TECHNICAL BULLETIN

PRODUCT: BUDERUS RC35

Buderus RC35 UPDATE V.21.06:

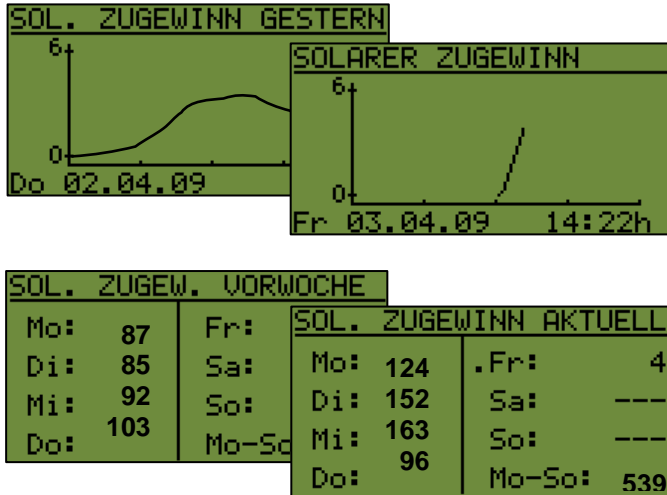
1. Improved functionality with MCM10, allowing better monitoring of the values when RC35 is connected to a cascade. Symbols are used to indicate the individual boiler status;

A B C D E

- A. Maintenance (service) or locking error exists
- B. Flue gas test active (is heating in chimney sweep mode)
- C. DHW demand (heating up the DHW system)
- D. Heating demand (central heating mode)
- E. Burner in operation (flame is lit)

No function test of individual boilers is possible via the relay mode in RC35 when connected to an MCM10 (this had led to confusion with the old version).

In a fault condition the display will now recognise faults via the MCM10 (not possible before);

This will mean that boiler faults can be read centrally from the RC35.

MCM10 software version can now be read from the RC35

The common flow temperature is displayed in the monitor section as “plant tmp” instead of the normal “boiler tmp”.

The RC35 will also not be able to display the boiler temperature or operating hours in the normal display.
